ADMINISTRATIVE

APPROVALS

April 02, 2025

1. 11 Sheafe Street

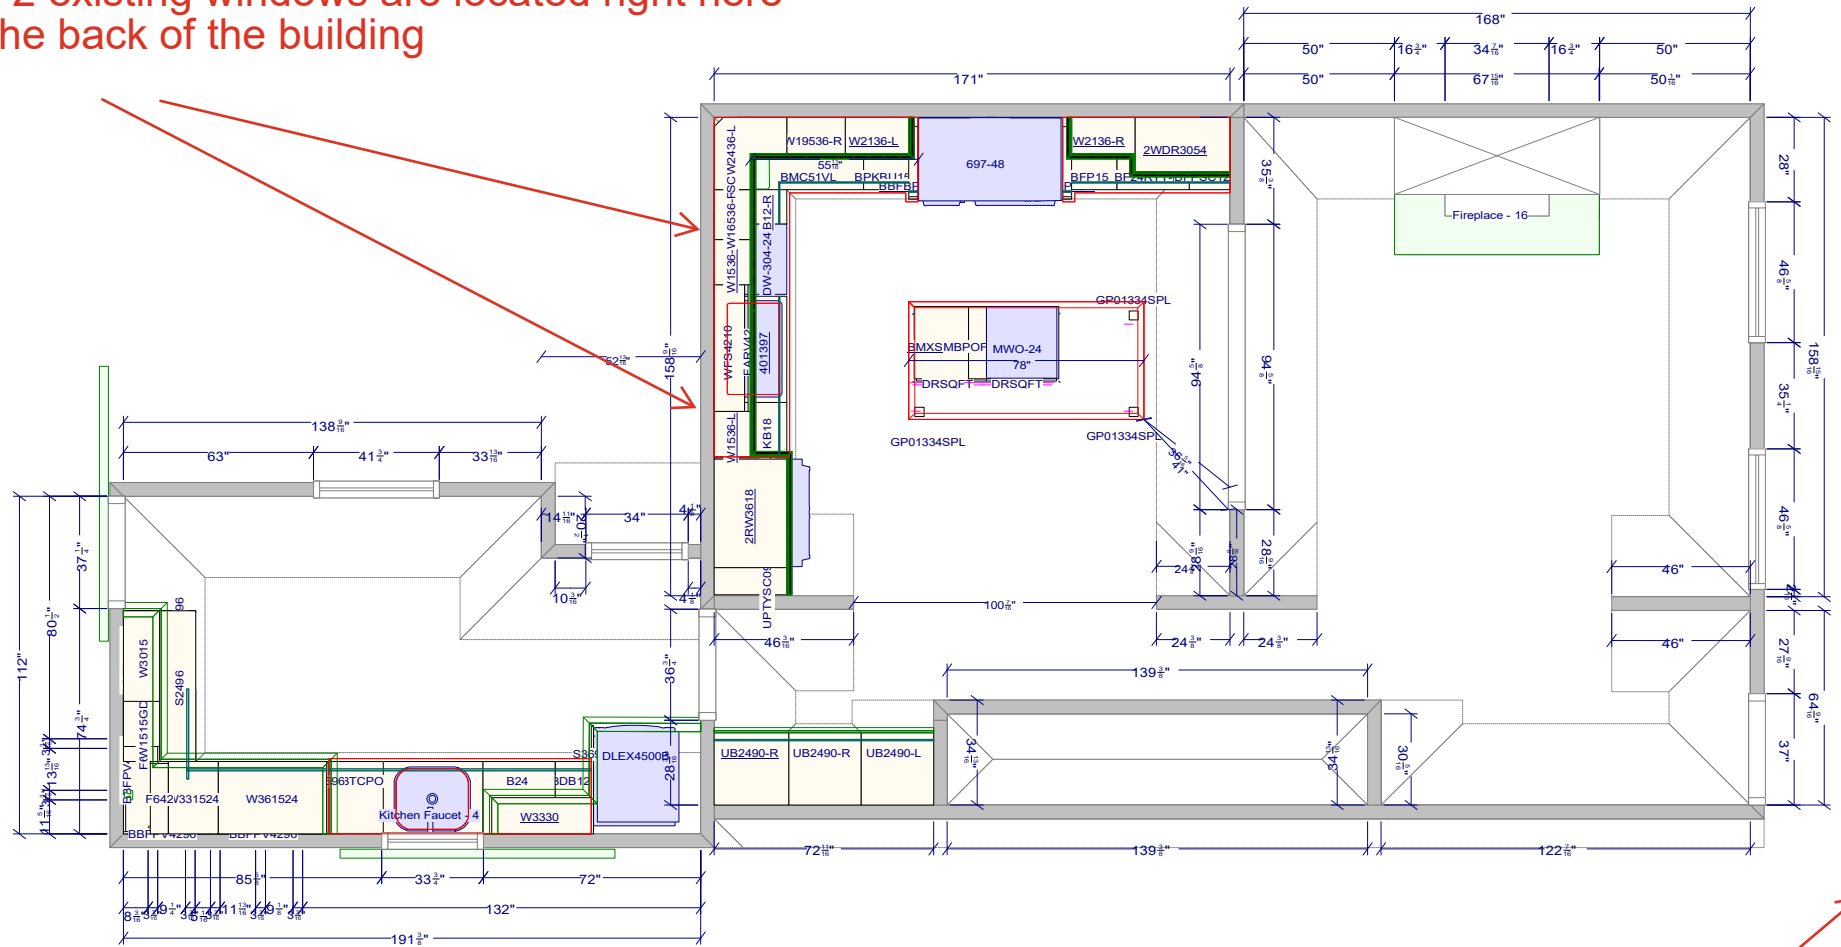
Background: The applicant is seeking approval to in-fill (2) existing windows on the rear side of the structure (to accommodate interior kitchen renovation). Applicant will use a lime based mortar.

The 2 existing windows are located right here
on the back of the building

PREVIOUSLY APPROVED & PROPOSED VIEWS

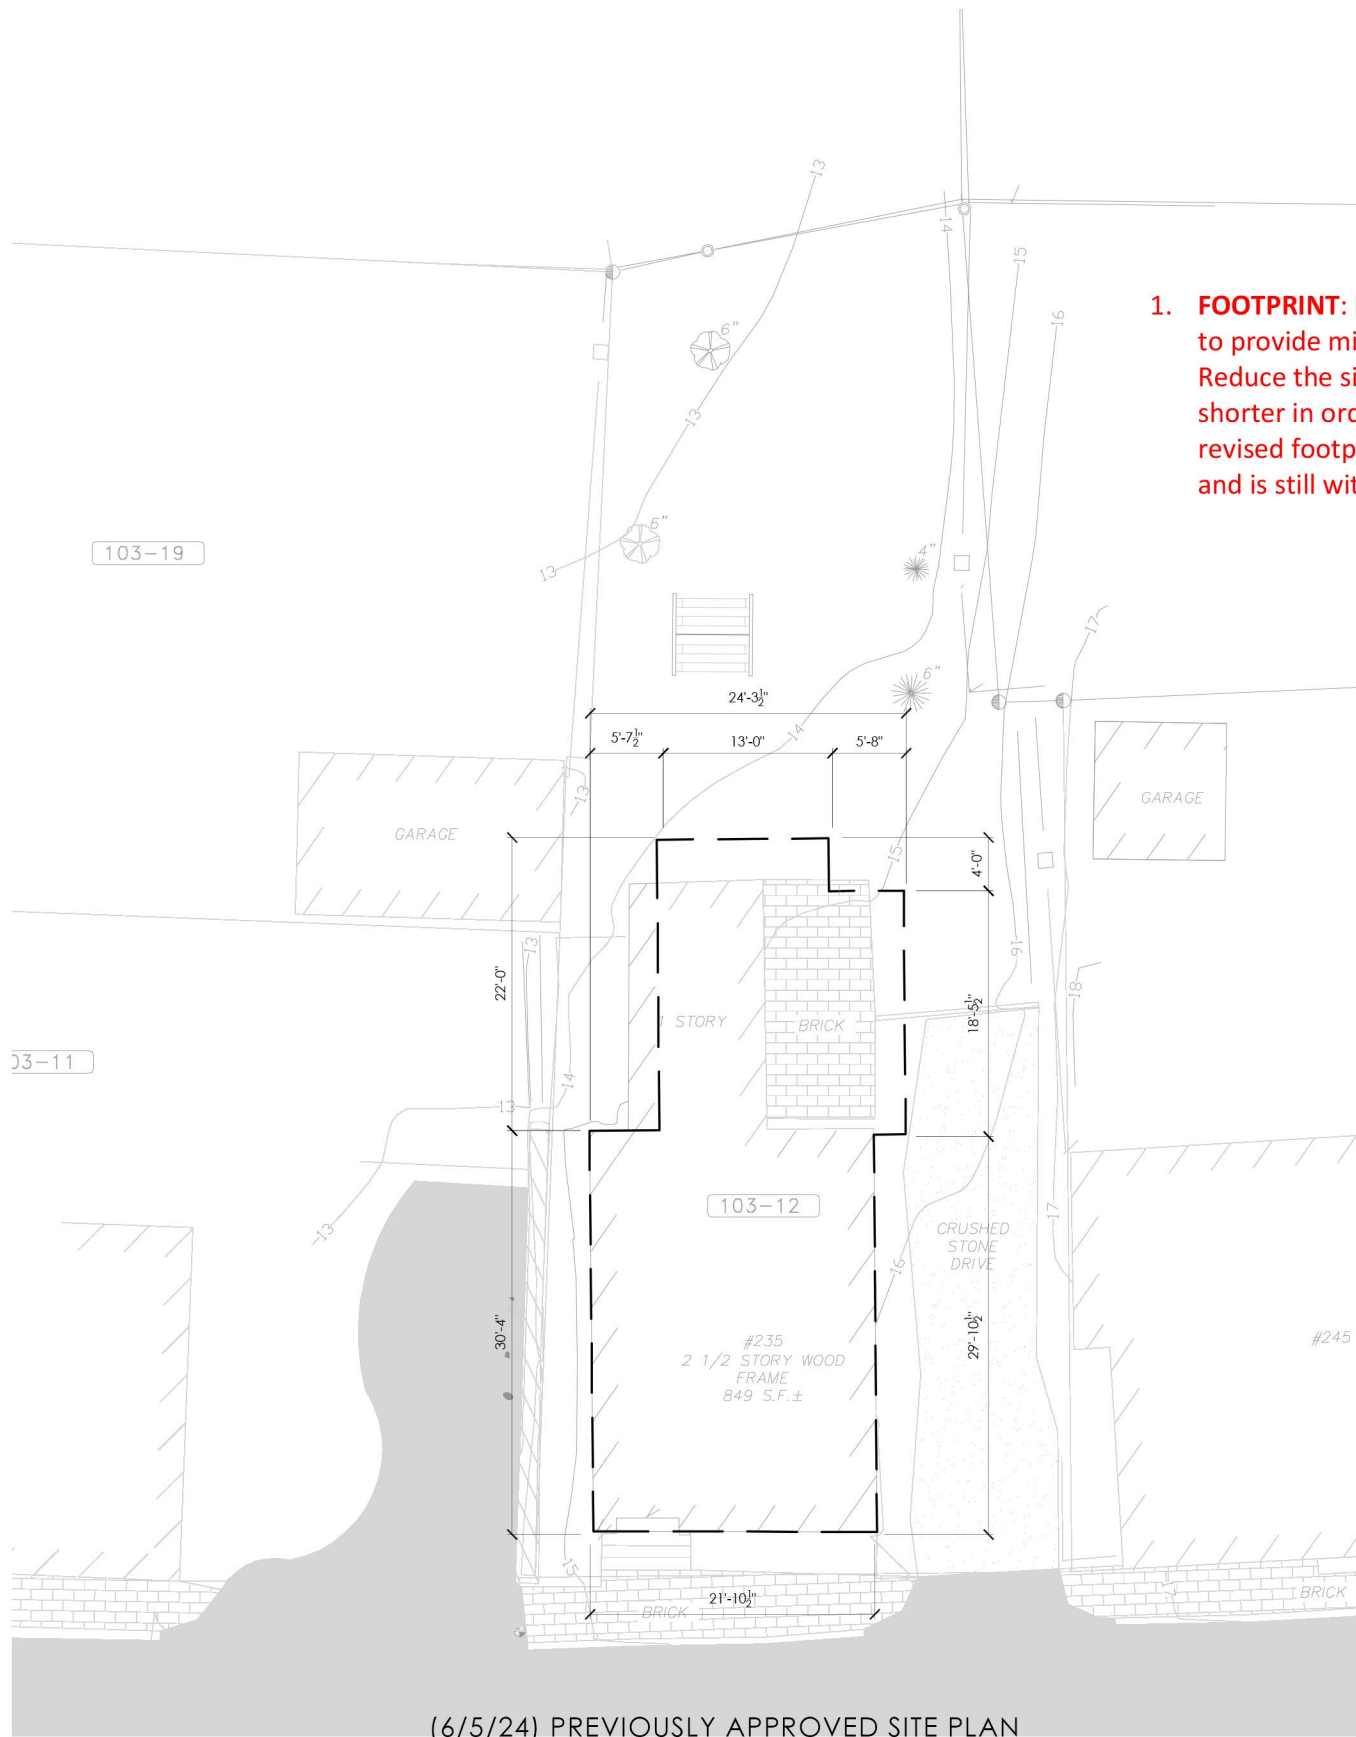
Background: The applicant is seeking approval for changes to a previously approved design (revise rear addition, change windows to casement for egress, add window, and revise window locations).

SITE PLAN

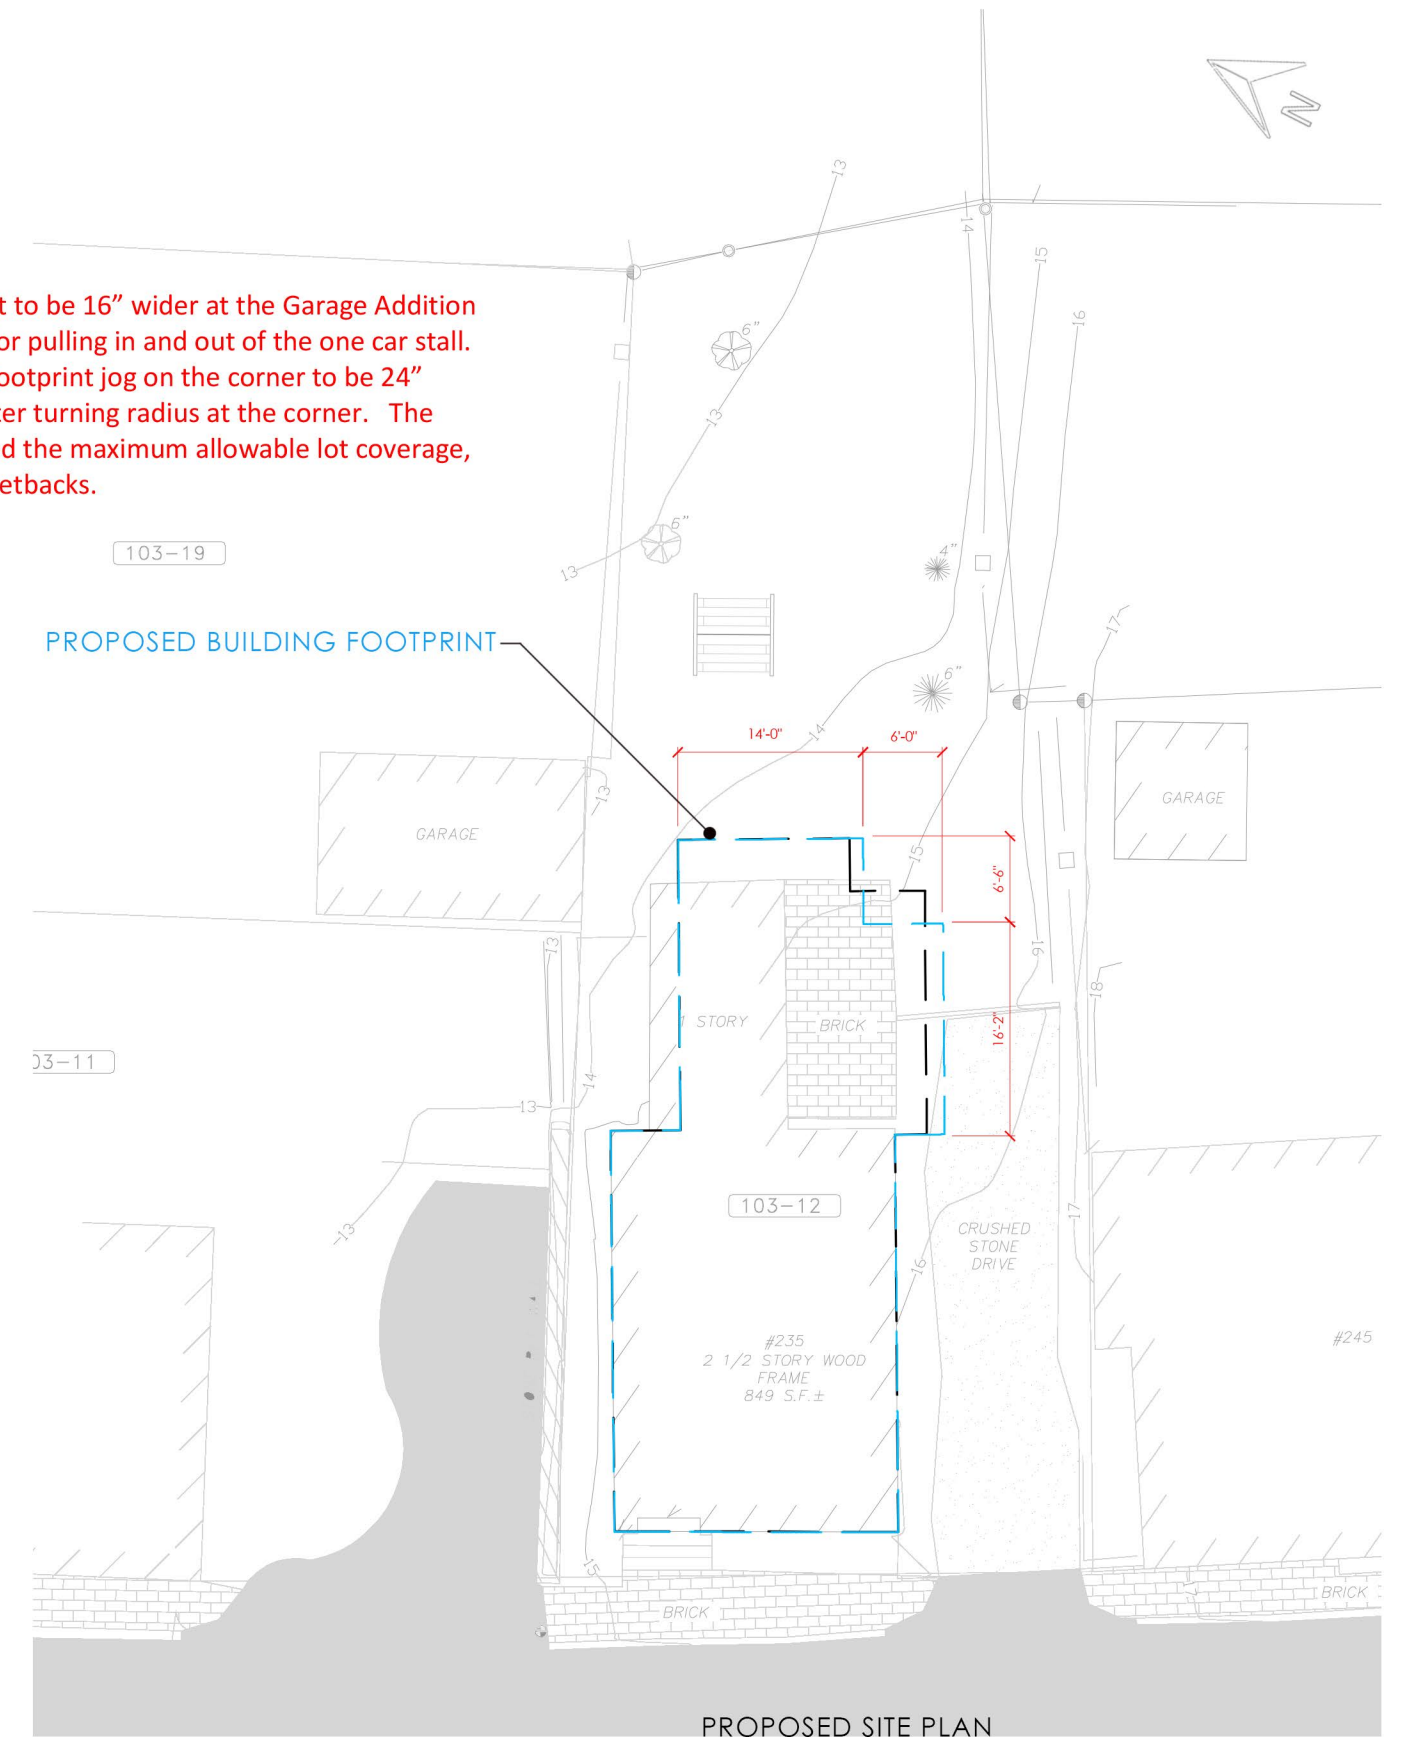
- FOOTPRINT:** Revise the footprint to be 16" wider at the Garage Addition to provide minimum clearance for pulling in and out of the one car stall. Reduce the size of the building footprint jog on the corner to be 24" shorter in order to facilitate better turning radius at the corner. The revised footprint does not exceed the maximum allowable lot coverage, and is still within the approved setbacks.

PREVIOUSLY APPROVED & PROPOSED ELEVATIONS

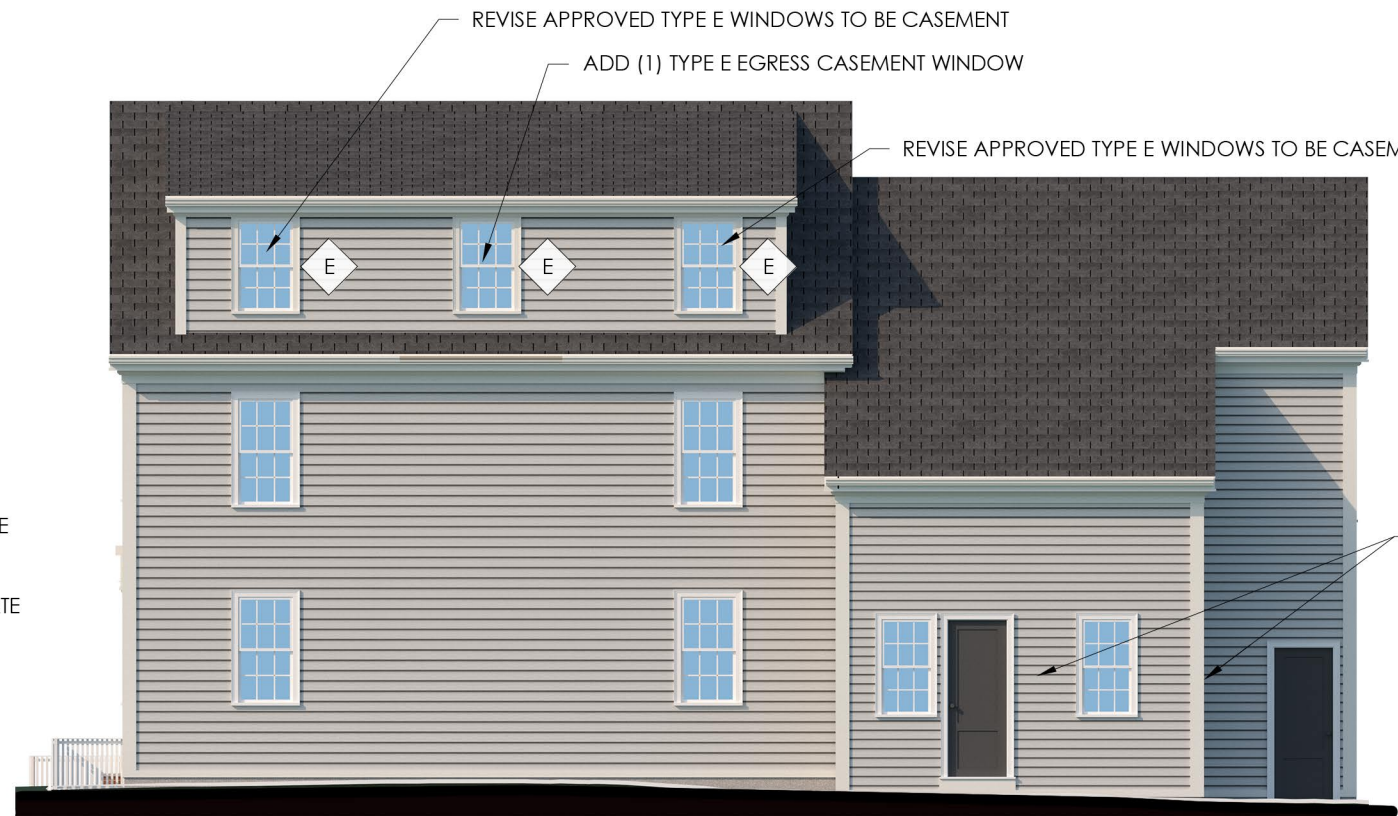
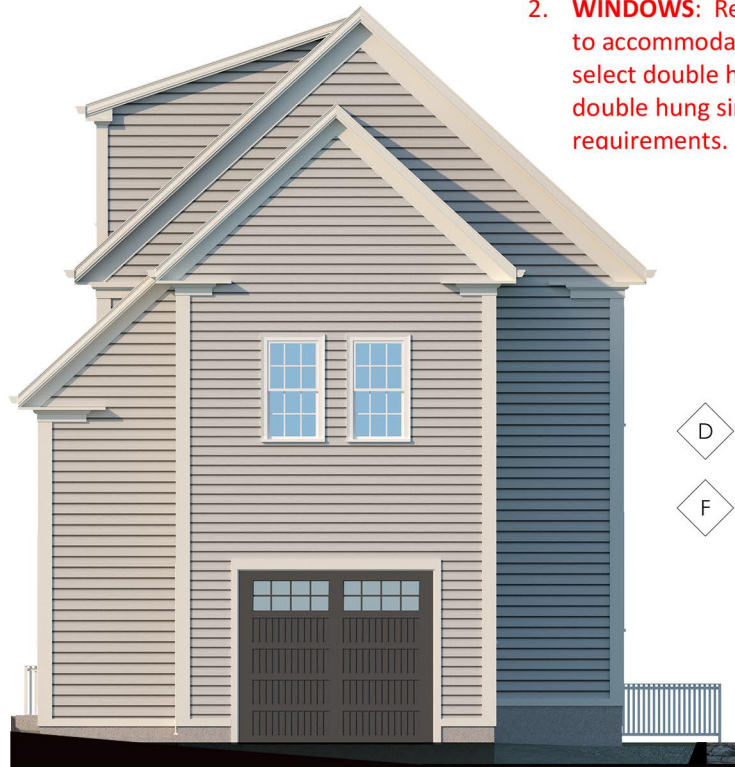
2. **WINDOWS:** Revise window placement on the addition to accommodate floor plan development, and revise select double hung windows to egress casements with double hung simulated meeting rail to meet egress requirements.

REVISE APPROVED WINDOW TO BE TYPE D EGRESS CASEMENT

REVISE APPROVED TYPE E WINDOWS TO BE CASEMENT

ADD (1) TYPE E EGRESS CASEMENT WINDOW

REVISE APPROVED TYPE E WINDOWS TO BE CASEMENT

DELETE WINDOW & REVISE EXTERIOR WALL LOCATION

- ◇ D 2'-5 1/2" x 4'-7 3/4" NEW MARVIN ELEVATE CASEMENT WINDOWS
- ◇ E 2'-5 1/2" x 3'-11 3/4" NEW MARVIN ELEVATE CASEMENT WINDOWS

PREVIOUSLY APPROVED & PROPOSED DEMO ELEVATION

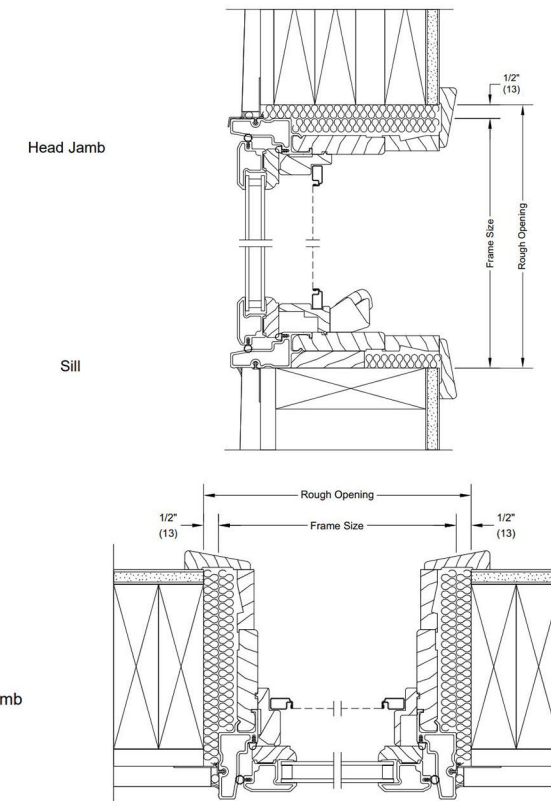
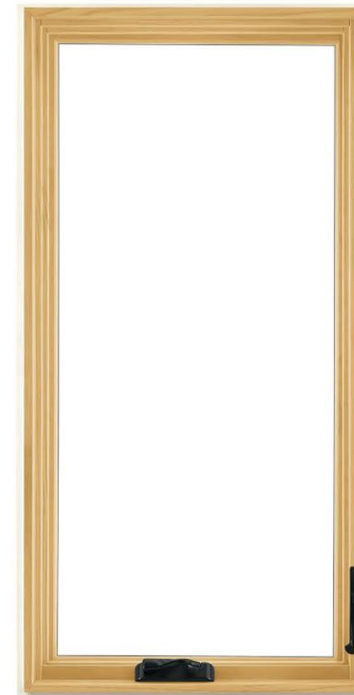
(REMOVE **B** DESIGNATION)

TO BE DEMOLISHED

3. **CLARIFICATION:** The existing historic building has five historic windows that will be restored and reinstalled in alternate locations on the building. One attic window on the back was approved with two conflicting notes indicating that the window is both restored and demolished. The window location will be covered by the new addition so the intent is to demolish the window.
